# Modification Recommended Service Note

## U7179-81000 - 16-Channel High Current Load Card up to 15A

Affected products: U8972A, U8989A, U8989AS, U8989B, U8989BS, E2240A, E2230B, E6198B, E8786B, E8780B

Figure 1. TestExec error

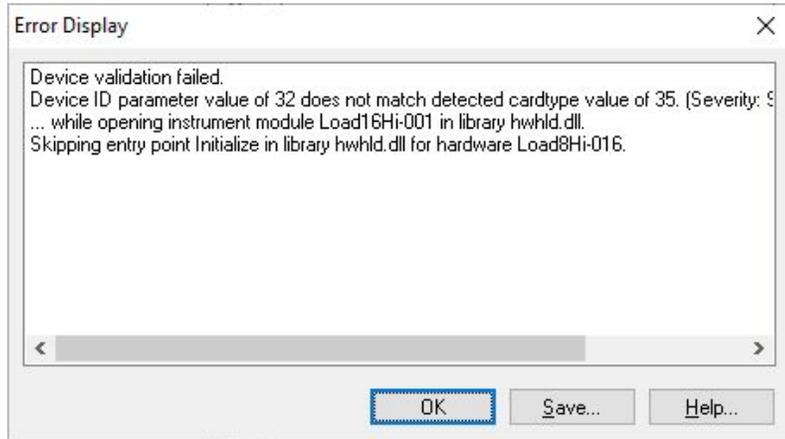
When all load cards are populated in the E6198B SLU (refer to Figure 2), the hardware ID of the U7179A load card in the left-most slot (slots 1 or 3) is not recognized correctly. The correct ID for U7179A card is 32, while the invalid IDs that have been observed could be 33, 35, 36, 37, 38, 39, 40, 41, 44, 46, and 47 (not fixed).

i.e. TestExec gives the following error message when it starts:

Figure 2. SCE screenshot

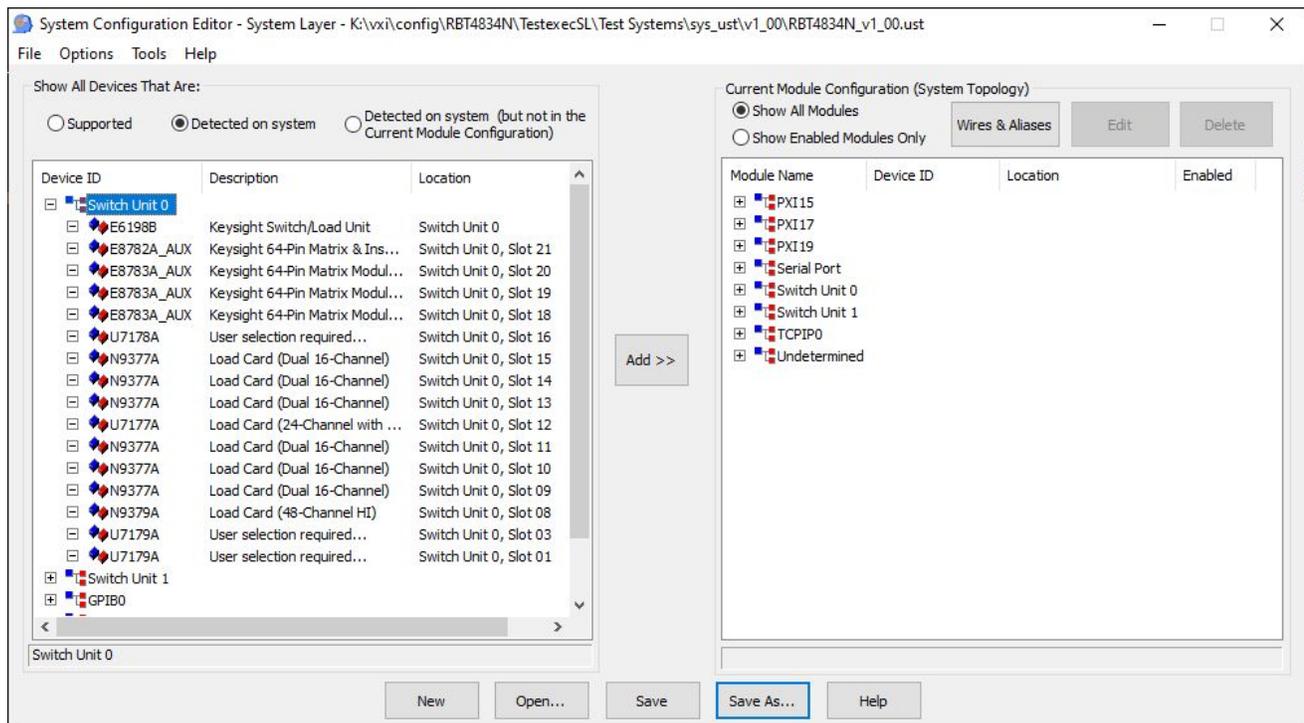
Hardware ID detection error only occurs if there are 10 or more cards in the SLU and happens at the left-most slot of the U7179A card. It is determined that a delay in control signals that are fed to the ID

IC from the specified manufacturers will result in a different U7179A ID. This delay causes the time mismatch on the timing diagram thus affecting U7179A ID signals.

Manufacturer Identification

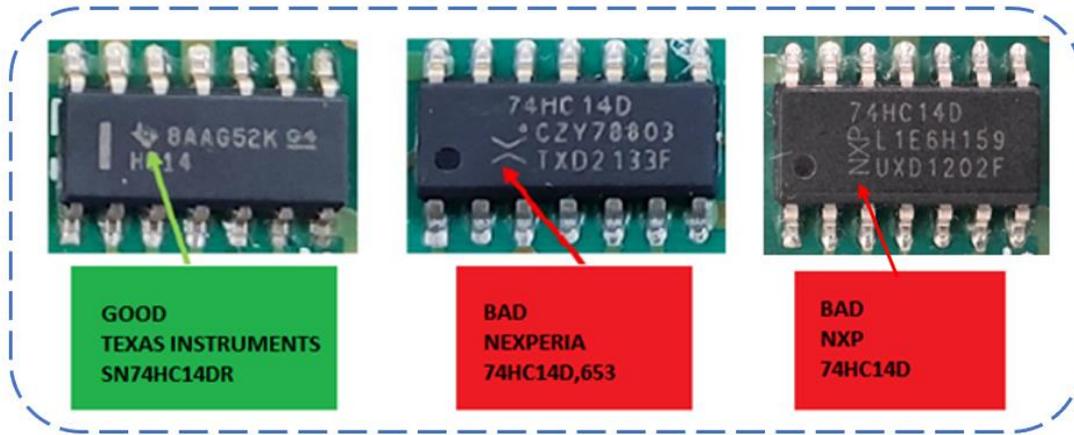
1. Perform a visual inspection to verify component body markings on the IC U23.

2. If the manufacturer mark indicates NEXPERIA or NXP, the card is identified as affected.
3. If the manufacturer mark indicates TEXAS INSTRUMENTS, no action is required.
